NL-07-0894

Edwin I. Hatch Nuclear Plant
Request to Implement an Alternative Source Term
Response to Request for Additional Information
Regarding the Power Sources for the Turbine Building Ventilation System

**Response to Request for Additional Information
Regarding the Power Sources for the Turbine Building Ventilation System**

Figure 1: Conceptual Design for TB Fan Power Supply Modification

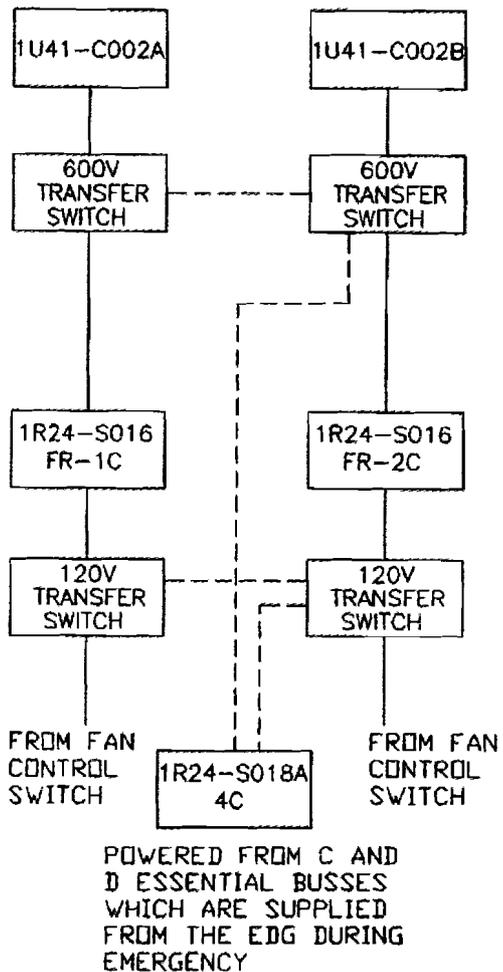
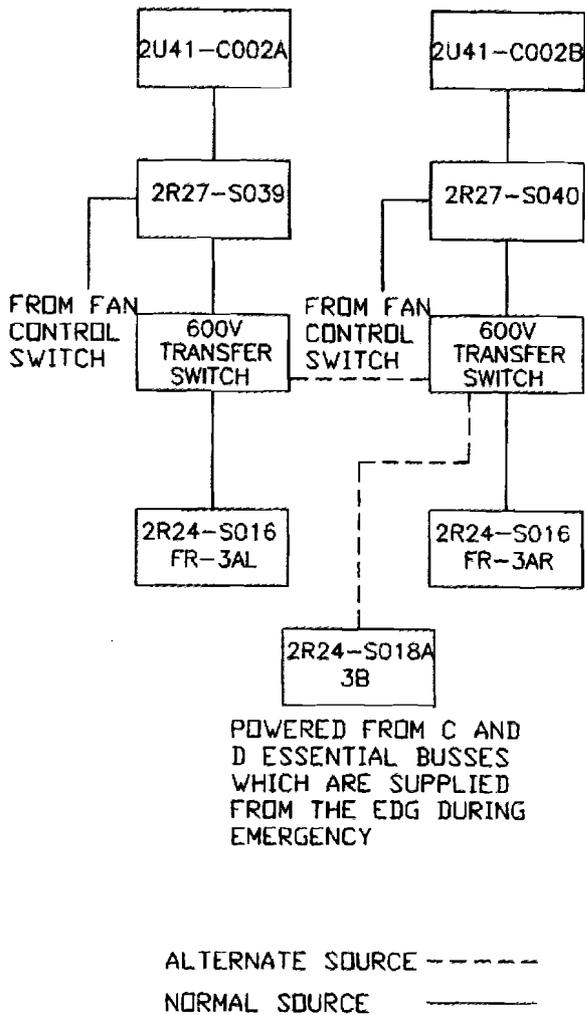
Please provide additional information to justify reliance on the ability to restore offsite power under all conditions and potential causes in the midst of a LOCA or other referenced DBA events or provide information as to how this system can be powered from an emergency power source.

The TB ventilation exhaust fans are currently powered from non-essential motor control centers (MCCs). The proposed modification involves providing an alternate power supply to each of the four TB ventilation exhaust fans from an emergency source. The emergency power source will be an essential MCC (one essential MCC for each unit) that has the capability of receiving power from an EDG. Having an essential MCC available from each HNP unit ensures that a single electrical failure will not prevent at least one TB exhaust fan from being placed in service post-DBA.

While the details of the modifications differ slightly between HNP units, the modifications for both units involve the use of manual switches to make the electrical connection between the emergency power supply and the TB ventilation exhaust fans. As described in AST submittal enclosure 1

section 2.7.3, the TB ventilation systems exhaust through the reactor building vent plenums. Specifically, the two Unit 1 TB ventilation exhaust fans are located outside the Unit 1 reactor building on a lower portion of the reactor building roof at elevation (EL.) 185'. The two Unit 2 TB ventilation exhaust fans are located in the ventilation room on EL. 203' of the Unit 2 reactor building. The manual switches for connecting to the emergency power supply will be located in the respective Unit 1 and 2 reactor buildings at EL. 164' in the vicinity of the normal power supplies for the TB ventilation exhaust systems, areas that are easily accessible post-DBA. Additionally, it is noted that the other components associated with the proposed modifications, including any necessary cable routing, will be in the respective HNP unit's reactor building. Details of the conceptual designs for each unit are provided in the following discussions and shown in Figure 1.

The Unit 1 TB ventilation exhaust fans are currently powered from MCC 1R24-S016, cubicles 1C and 2C. The MCC supplies non-essential loads, and therefore, does not have the capability of being powered from an emergency source. The conceptual design provides an alternate starter located within the 1R24-S018A MCC that would be used to supply power to either one of the Unit 1 TB ventilation exhaust fans in the event that the normal (non-essential) power supply was unavailable. The 1R24-S018A MCC is powered from the essential 600-V bus 2C which is powered from an EDG when offsite power is not available. Four manual transfer switches, two per fan, would be required to 1) align power to either of the two Unit 1 TB ventilation exhaust fan motors from the cubicle located in 1R24-S018A and 2) align control power to the main control room to provide control and indication to the operators. The two switches for aligning power to the TB ventilation exhaust fan motors would be 600-V manual disconnect switches and the two switches for aligning control power to the control room would be 120-V rotary switches. All four switches would be located in the reactor building in the vicinity of the normal power supply (MCC 1R24-S016) to allow operations personnel the ability to operate the switches, if required, post-DBA.

The Unit 2 TB ventilation exhaust fans are currently powered from MCC 2R24-S016, cubicles 3AL and 3AR. The MCC supplies non-essential loads, and therefore, does not have the capability of being powered from an emergency source. The proposed design modification for Unit 2 utilizes an alternate power supply to be used for either exhaust fan from the 2R24-S018A MCC. This would provide an emergency source of power to either one of the two TB ventilation exhaust fans in the event that the normal power supply was unavailable. The 2R24-S018A MCC is powered from the essential 600-V bus 1C which is powered from an EDG when offsite power is not available.

Two 600-V manual disconnect switches, one per fan, would be required to align power to either local starter from the cubicle located in 2R24-S018A. Since the control power interface is located at the starter itself, a separate switch would not be required to realign the control power supply in order to start the TB ventilation exhaust fans. The manual transfer switches would be located in the reactor building in the vicinity of the normal power supply to allow operations personnel the ability to operate the switches post-accident. Again this design maintains the capability for remote operation of the TB ventilation exhaust fans from the main control room.
